Product Change Notification / ASER-23WWAI681

CCB 4235 Final Notice: Qualification of MMT as a new final test site for selected Atmel AT27C/BV/LVxxxPU/JUxxx products

Description of Change:Qualification of MMT as a new final test site for selected Atmel AT27C/BV/LVxxxPU/JUxxx products.

32L PLCC Tube Packing : MMT

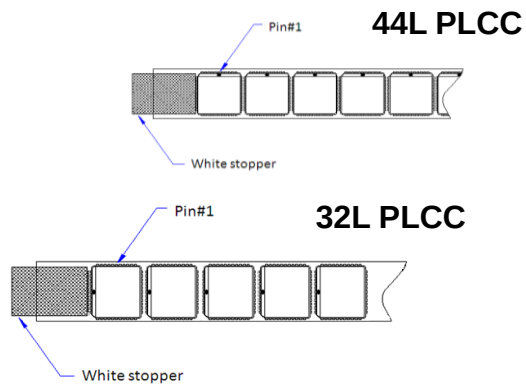
1. Pin 1 Orientation

2. Tube Bundling

PLCC 32 – 30 tubes per bag
PLCC 44 – 20 tubes per bag

PLCC 32 CARRIER TAPE

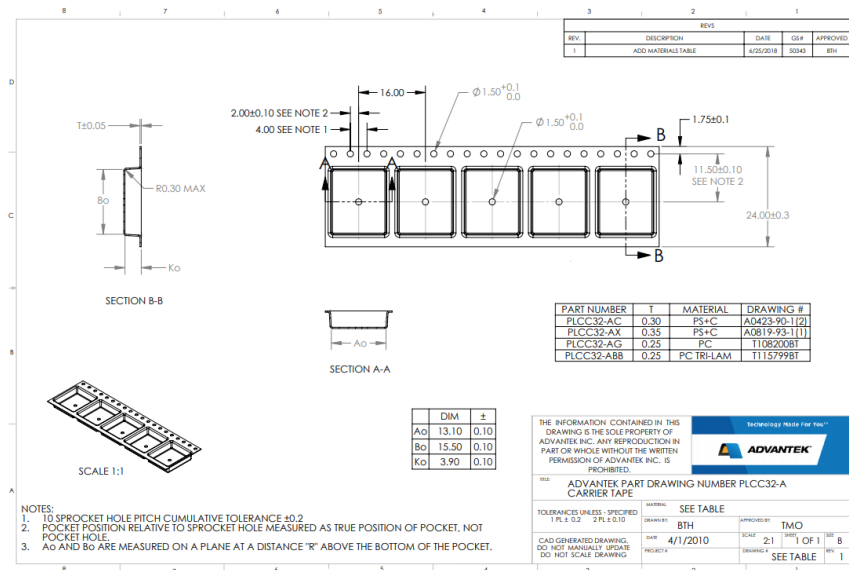
Supplier	Mfg. Part No.	W (mm.) ±0.3 or Specific	P (mm.) ±0.1 or Specific	A_0 ±0.1 or Specific	B_0 ±0.1 or Specific	K_0 ±0.1 or Specific	Thickness
Advantek	PLCC32-AC170.M1	24	16	13.10/-0.1	15.50+/-0.1	3.90+/-0.10	0.30 +/-0.05

PLCC 44 CARRIER TAPE

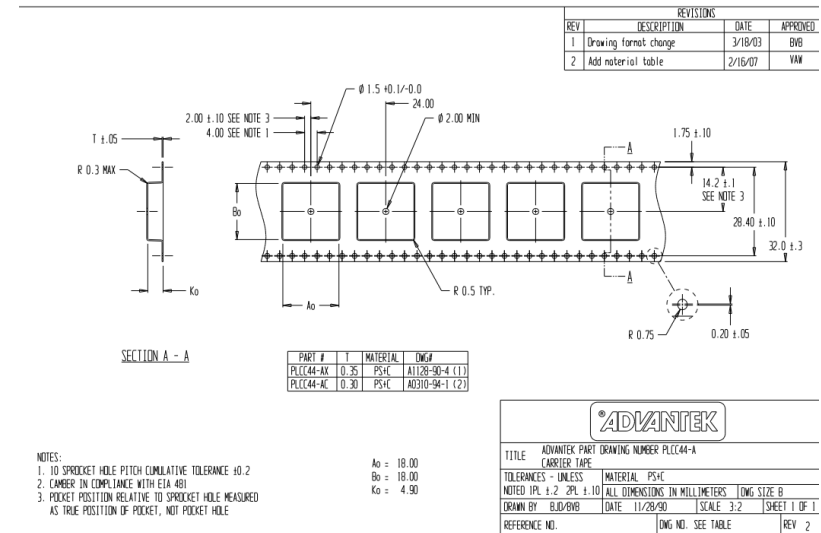
Supplier	Mfg. Part No.	W (mm.) ±0.3 or Specific	P (mm.) ±0.1 or Specific	A_0 ±0.1 or Specific	B_0 ±0.1 or Specific	K_0 ±0.1 or Specific	Thickness
Advantek	PLCC44-AC88.0R5	32	24	18+/-0.1	18+/-0.1	4.9+/-0.1	0.30 +/-0.05

PLCC 32 COVER TAPE (Width: 24mm)

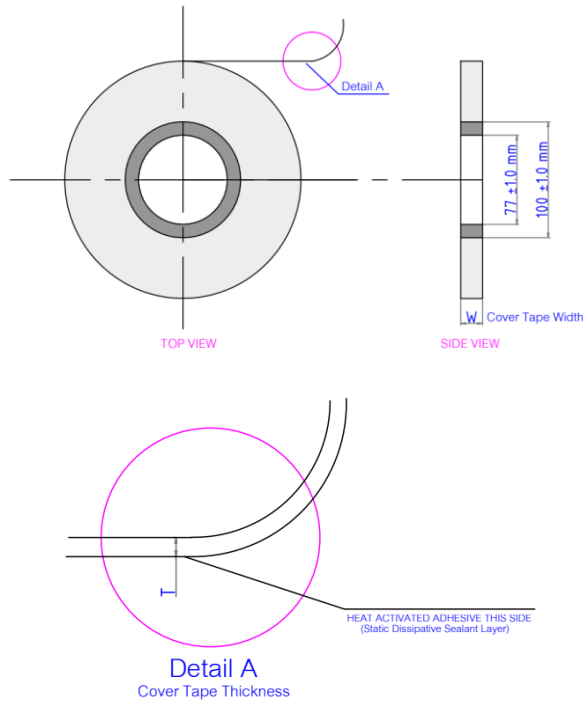
Carrier Width	Supplier	MCHP P/N	Supplier Part	Width "W" (mm)	Thickness (mm)	Sealing Mythology
24mm	Sumitomo	22102002	CSL-Z7302	21.0 +/- 0.1	0.050 ±0.010	Heat Sealing

PLCC 44 COVER TAPE (Width: 32mm)

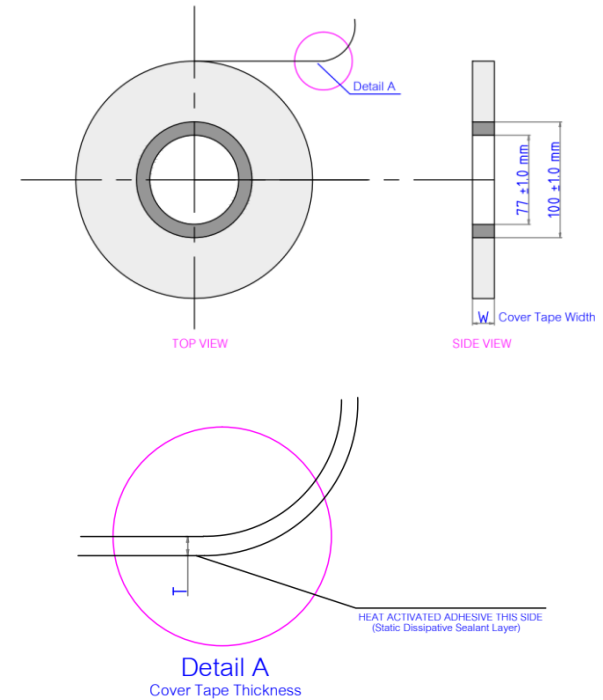
Carrier Width	Supplier	MCHP P/N	Supplier Part	Width "W" (mm)	Thickness (mm)	Sealing Mythology
32mm	Sumitomo	22104401	CSL-Z7302	25.5 +/- 0.1	0.050 ±0.010	Heat Sealing

PLCC 32L

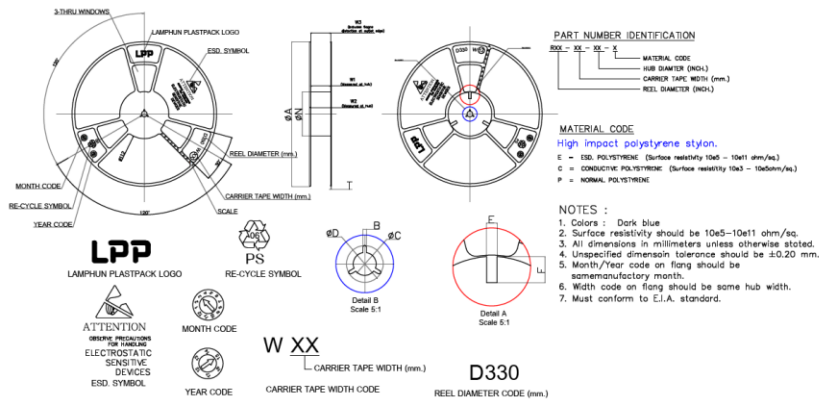
Width	MCHP P/N	Supplier Part	Hub	Color
24mm	23000024	R13-24-04-E	4inch (100mm)	Dark Blue

Description	MPHIL	MMT
Color	White	Dark blue
Diameter	329.99 +/- 1.0	330 +/- 2.0
Hub	100	100 +/- 2.0
Width	25.5 +/- 0.5	24.4 +/- 2.0

PLCC 44L

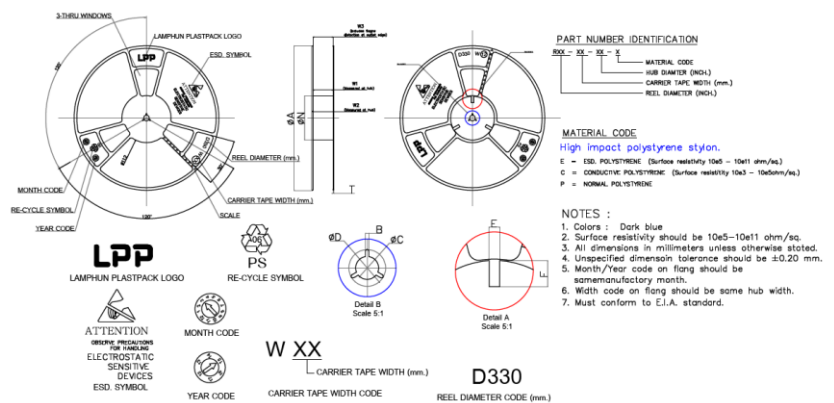
Width	MCHP P/N	Supplier Part	Hub	Color
32mm	23000023	R13-32-04-E	4inch (100mm)	Dark Blue

Description	MPHIL	MMT
Color	White	Dark blue
Diameter	329.99 +/- 1.0	330 +/- 2.0
Hub	100	100 +/- 2.0
Width	33 +/- 0.5	32.4 +/- 2.0
